UNITED STATES PATENT AND TRADEMARK OFFICE

10/528,713

Office Action Summary	Application No. 10/528,713	Applicant(s) FOUARGE ET AL.	
	Examiner WILLIAM K. CHEUNG	Art Unit 1796

DETAILED ACTION

FIG. 1

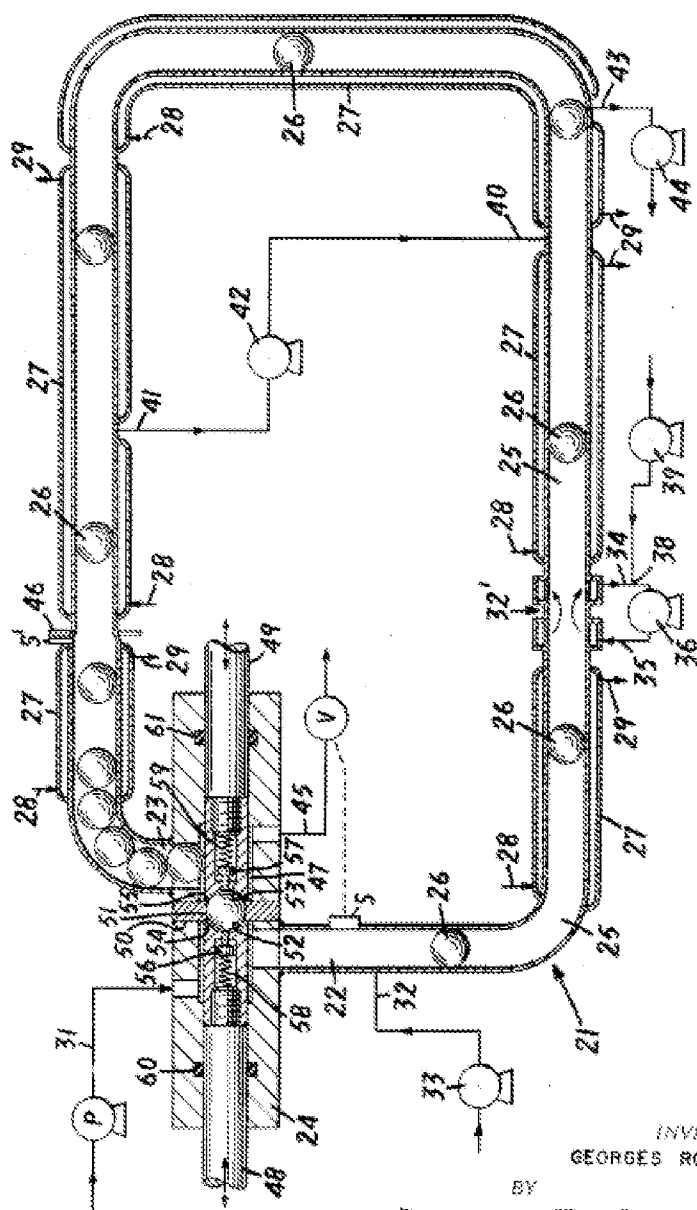
Rouzier et al. (Figure 1; col. 1, line 23-30) disclose a polymerization process for ethylene (col. 3, line 29) in the presence of heptane and catalyst (col. 6, line 49), where the monomer can be feed through line 31 of the reactor. Rouzier et al. (col. 3, line 51-55; col. 6, line 46-50) clearly disclose a polymerization process involving the circulation of monomers in a slurry of polymer (fluff) partitioned off by movable separators (or the obstacles as claimed). Regarding the claimed “flowing a portion of the slurry through a bypass line extending from one location of the loop reactor to another location of the same loop reactor”, Rouzier et al. (Figure 1; col. 6, line 51-55) disclose “flowing a portion of the slurry through a bypass line (item 41) through a pump (item 42) through line (item 40) to another location of the same loop reactor. Regarding the claimed “withdrawing a portion of the slurry from the loop reactor as a polymer product”, Rouzier et al. (Figure 1; col. 7, line 6-8) disclose that portion of the slurry can be drawn off by

means of a pump through line 43. For circulating the slurry, Figure 1 of Rouzier et al.

clearly disclose the use of pumps (item 36, 39, 42).

The difference between the invention of claims 17-30, 34-36, 38 and Rouzier et al. is that Rouzier et al. do not disclose “circulating the slurry through the loop reactor at an efficiency of from 30-75% of a pump capacity”.

However, Rouzier et al. in Figure 1 clearly disclose the use of pumps (item 36, 39, 42). Although Rouzier et al. do not disclose “circulating the slurry through the loop reactor at an efficiency of from 30-75% of a pump capacity”, it would not be difficult to one of ordinary skill in art to recognize that the pump for circulating the polymer slurry should be run at a safe range or capacity within the capability of a pump to avoid equipment failure. Motivated by the expectation of success of developing a polymerization process for polymerizing ethylene, it would have been obvious to circulate the slurry at an efficiency that is not too low or too high capacity relative to the maximum capacity of a pump to obtain the a range that fully encompasses the 30-75% of a pump capacity feature as claimed.

Regarding the difference between the invention of claims 17-30, 34-36, 38 and Rouzier et al. that Rouzier et al. do not disclose the amount to be bypassed, applicants must recognize that Rouzier et al. in Figure 1 clearly disclose “flowing a portion of the slurry through a bypass line (item 41) through a pump (item 42) through line (item 40) to another location of the same loop reactor”. Therefore, generically, the examiner has a reasonable basis to believe that the amount as claimed in claims 18, 19, 26, 27 is included in the amount as taught in Rouzier et al. Motivated by the expectation of success of developing the process of Rouzier et al., it would have been obvious to one of ordinary skill in art to apply “routine experimental design” to obtain the amount feature

Regarding the difference between the invention of claims 20-22 and Rouzier et al. that Rouzier et al. do not disclose the angle between the bypass line and the loop reactor, applicants must recognize that Rouzier et al. in Figure 1 clearly disclose “flowing a portion of the slurry through a bypass line (item 41) through a pump (item 42) through line (item 40) to another location of the same loop reactor”. Although diagrammatically, the angle is between the bypass line and the loop reactor is at 90 degree. However, the examiner believes that the said angle should not be restricted by Figure 1 because it is merely a technically drawing describing a concept. However, the examiner has a reasonable basis to believe that the angle as claimed in claims 20-22 is generically taught in Figure 1 Rouzier et al. Motivated by the expectation of success of developing the process of Rouzier et al., it would have been obvious to one of ordinary skill in art to apply “routine experimental design” to obtain the angle feature of claims 20-22. To obtain a valid patent, applicants should submit comparative data to show the criticality of the claimed angles of claims 20-22.

Regarding the difference between the invention of claims 23, 24 and Rouzier et al. that Rouzier et al. do not disclose ratio DB/DL range as claimed, applicants must recognize that Rouzier et al. in Figure 1 clearly disclose “flowing a portion of the slurry through a bypass line (item 41) through a pump (item 42) through line (item 40) to another location of the same loop reactor”. Since the bypass line is for pumping a

portion of the slurry to be recirculated, it would not be difficult for one of ordinary skill in art to recognize that the bypass line is not required to be same diameter of the loop reactor or to have the same capacity of the loop reactor. Therefore, motivated by the expectation of success of developing the process of Rouzier et al., it would have been obvious to one of ordinary skill to employ a DB/DL ratio of less than 1 to obtain the invention of claims 23, 24. To obtain a valid patent, applicants should submit comparative data to show the criticality of the claimed range of DB/DL ratio of claims 23, 24.

Regarding the difference between the invention of claims 25-28 and Rouzier et al. that Rouzier et al. do not disclose that the recirculation of the slurry from the pressure side of the impeller blades of said pump to the suction side of the impeller blades of said pump, applicants must first recognize that Rouzier et al. in Figure 1 clearly disclose "flowing a portion of the slurry through a bypass line (item 41) through a pump (item 42) through line (item 40) to another location of the same loop reactor". Further, applicants must recognize that it is well known in the art that the pumps for this particular application are typically performed with pumps having impeller blades. While the impellers are in action for recirculating the said slurry, the action creates a suction side and pressure side. Further, on the pressure side, the slurry is being pumped to the other side of the loop reactor to be recirculated. Portion of the recirculated slurry will be drawn to the suction side of the loop reactor.

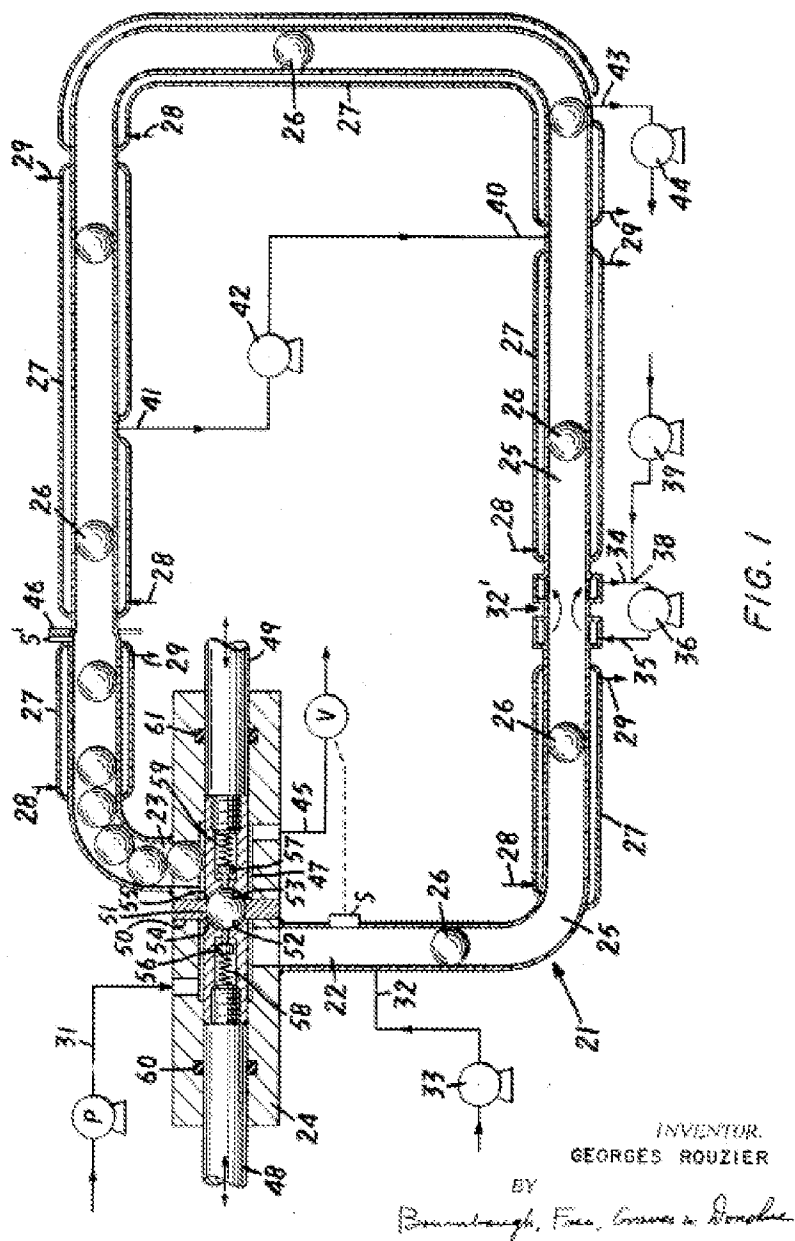
recirculated, applicants must recognize that Rouzier et al. in Figure 1 clearly disclose “flowing a portion of the slurry through a bypass line (item 41) through a pump (item 42) through line (item 40) to another location of the same loop reactor”. Therefore, generically, the examiner has a reasonable basis to believe that the percent of the portion of the slurry to be recirculated as claimed in claims 26, 27 is included in the percent as taught in Rouzier et al. Motivated by the expectation of success of developing the process of Rouzier et al., it would have been obvious to one of ordinary skill in art to apply “routine experimental design” to obtain the percent feature of claims 26, 27. To obtain a valid patent, applicants should submit comparative data to show the criticality of the claimed percent to be bypassed of claims 26, 27.

Rouzier et al. (Figure 1; col. 1, line 23-30) disclose a polymerization process for ethylene (col. 3, line 29) in the presence of heptane and catalyst (col. 6, line 49), where the monomer can be feed through line 31 of the reactor. Rouzier et al. (col. 3, line 51-55; col. 6, line 46-50) clearly disclose a polymerization process involving the circulation of monomers in a slurry of polymer (fluff) partitioned off by movable separators (or the obstacles as claimed). Regarding the claimed “flowing a portion of the slurry through a bypass line extending from one location of the loop reactor to another location of the same loop reactor”, Rouzier et al. (Figure 1; col. 6, line 51-55) disclose “flowing a

portion of the slurry through a bypass line (item 41) through a pump (item 42) through line (item 40) to another location of the same loop reactor. Regarding the claimed “withdrawing a portion of the slurry from the loop reactor as a polymer product”, Rouzier et al. (Figure 1; col. 7, line 6-8) disclose that portion of the slurry can be drawn off by means of a pump through line 43. For circulating the slurry, Figure 1 of Rouzier et al. clearly disclose the use of pumps (item 36, 39, 42).

However, Rouzier et al. in Figure 1 clearly disclose the use of pumps (item 36, 39, 42). Although Rouzier et al. do not disclose “circulating the slurry through the loop reactor at an efficiency of from 30-75% of a pump capacity”, it would not be difficult to one of ordinary skill in art to recognize that the pump for circulating the polymer slurry should be run at a safe range or capacity within the capability of a pump to avoid equipment failure. Motivated by the expectation of success of developing a polymerization process for polymerizing ethylene, it would have been obvious to circulate the slurry at an efficiency that is not too low or too high capacity relative to the maximum capacity of a pump to obtain the a range that fully encompasses the 30-75% of a pump capacity feature as claimed.

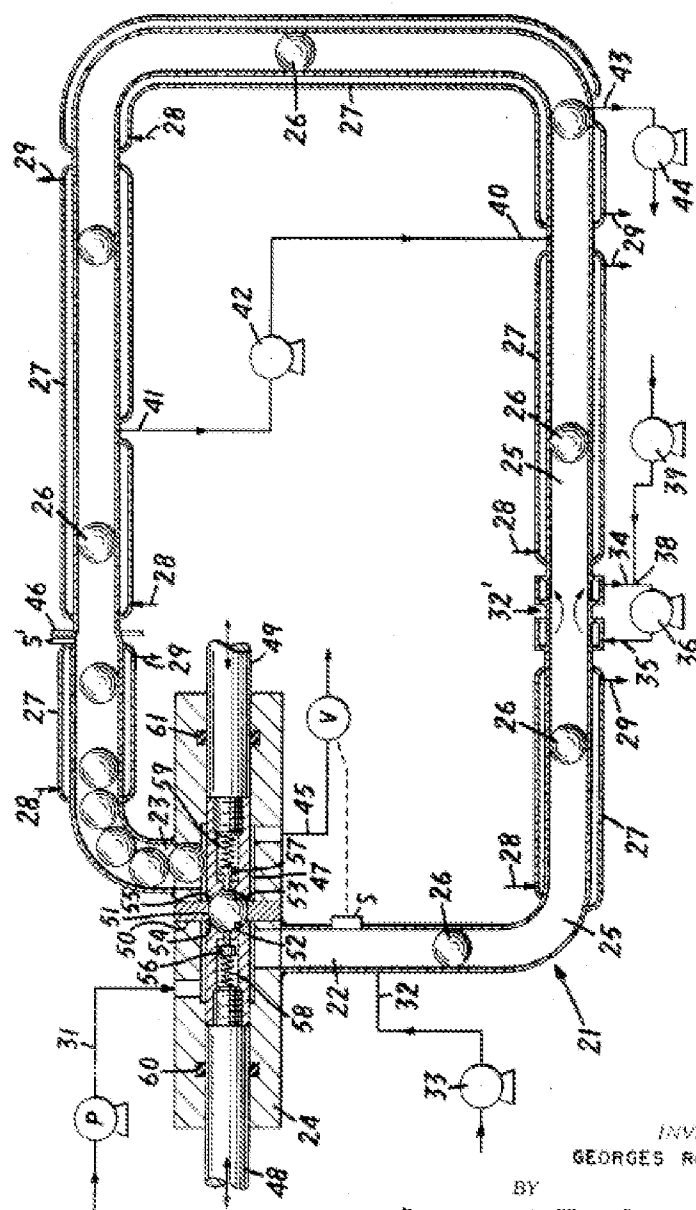
8. Applicant's arguments filed April 1, 2008 have been fully considered but they are not persuasive. Applicants argue that the bypass line of Rouzier et al. is not part of the loop reactor disclosed. However, applicants do not provide any reasons or evidence to support the allegation that the bypass line is not part of the loop reactor disclosed. Nevertheless, since Rouzier et al. (Figure 1) clearly teach a loop reactor comprising the bypass line 40 to 41, the examiner has a reasonable that Rouzier et al. clearly teach reactor as claimed.

Applicants must first recognize that Rouzier et al. in Figure 1 clearly disclose "flowing a portion of the slurry through a bypass line (item 41) through a pump (item 42) through line (item 40) to another location of the same loop reactor". Further, applicants must recognize that it is well know in the art that the pumps for this particular application are typical performed with pumps having impeller blades. Therefore, both Rouzier et al. and Weinreich et al. relate substantially identical endeavors of using a pump and its impeller blades for achieving better mixing. In view of the reasons set forth above, the combined teachings of Rouzier et al. and Weinreich et al. are proper for the instant 103 rejection.
